WARRANTY INFORMATION **SERVICE INFORMATION**

575 SCi Throttle Opening Adjustment

▲ = Revised September 2000

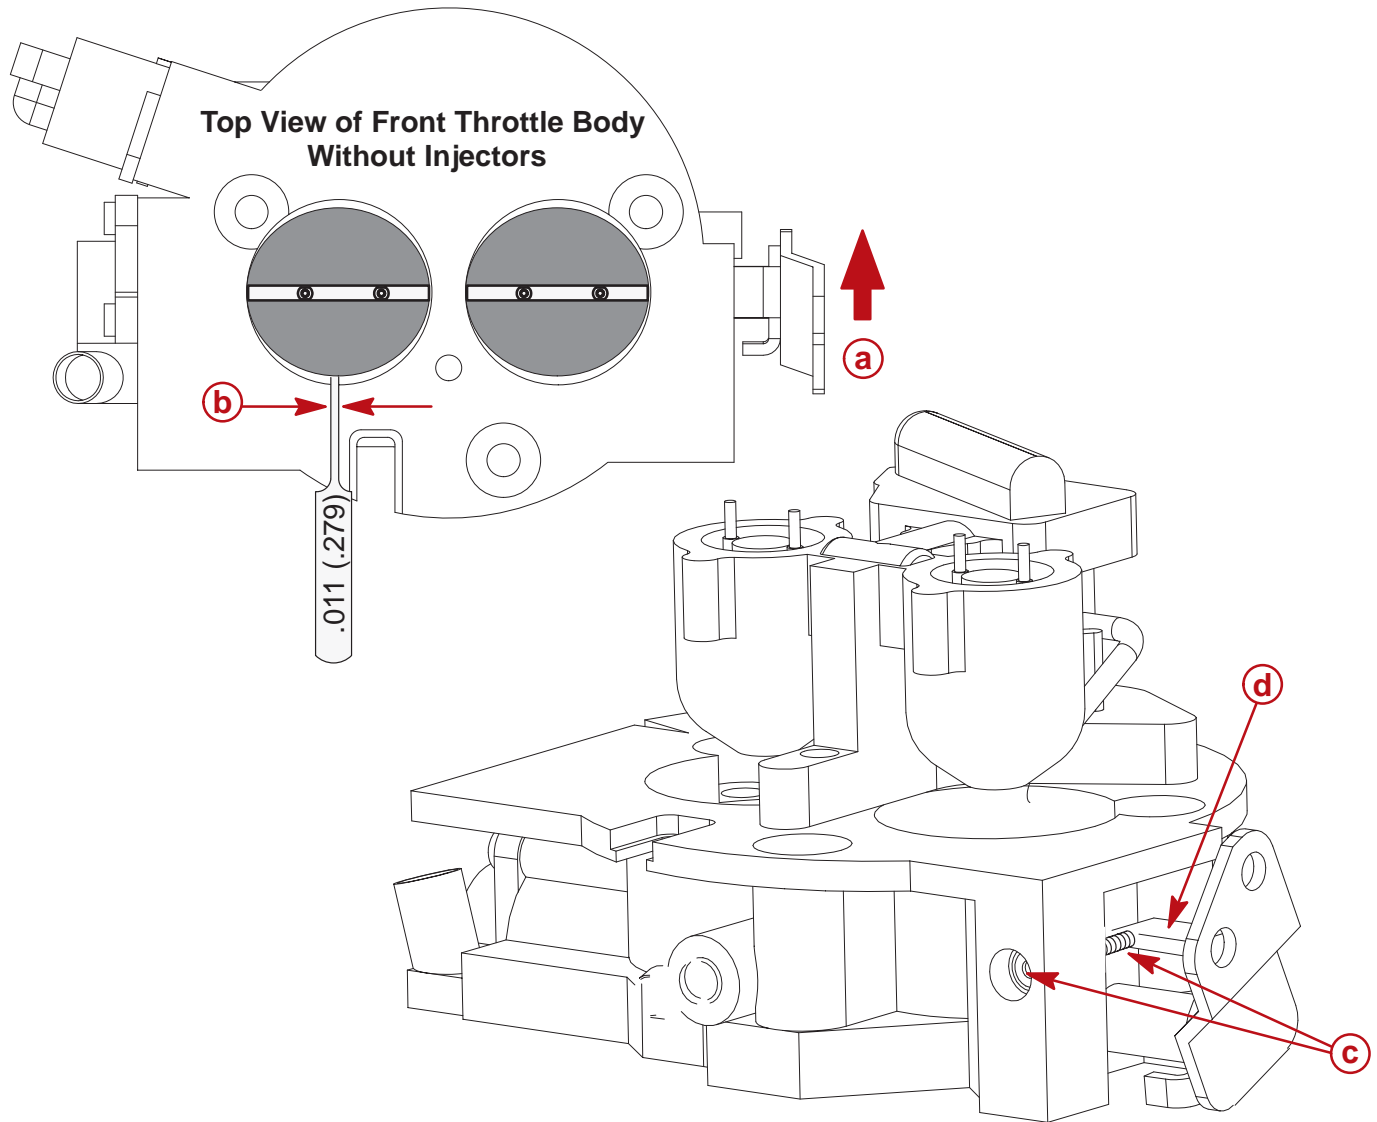
▲Any 575 SCi engine serial number 0L601000 through 0L602090 could have the front throttle plate set incorrectly. Read the symptoms under the "Problem" heading to determine if your engine's throttle plates may have been set incorrectly at the factory. All 2001 Model Year engines with model codes ending with the letters PH have the throttle plates set correctly and are not affected by this bulletin.

Engine stalls when put into gear. If using the Digital Diagnostic Tester (DDT) to check the Idle Air Control Follower (IAC) setting in neutral, the reading is at 100 plus counts.

1. Disconnect throttle cable from cable end guide.
2. Remove flame arrestor.
3. ▲Use a modified 0.011 in. (0.279 mm) feeler gauge with a blade not wider than 1/8 in. (0.125 in. [3.175 mm]) to verify the throttle plate opening on the FRONT THROTTLE BODY ONLY. There should be drag on the feeler gauge for correct setting.
4. If adjustment is required, remove sealer that is covering access to the throttle stop screw and adjust screw to set gap at 0.011 in. (0.279 mm). Ensure that throttle lever contacts throttle stop screw.

5. With gap set and screw adjusted, fill in access to the throttle stop screw with silicone sealant. **This screw should never be used to adjust engine idle speed.**

- a** - Throttle Opening Direction
- b** - Maximum Blade Width 1/8" (0.125 mm)
- c** - Throttle Stop Screw (Adjust Front Throttle Body Only)
- d** - Throttle Lever (Should Make Contact with Throttle Stop Screw)
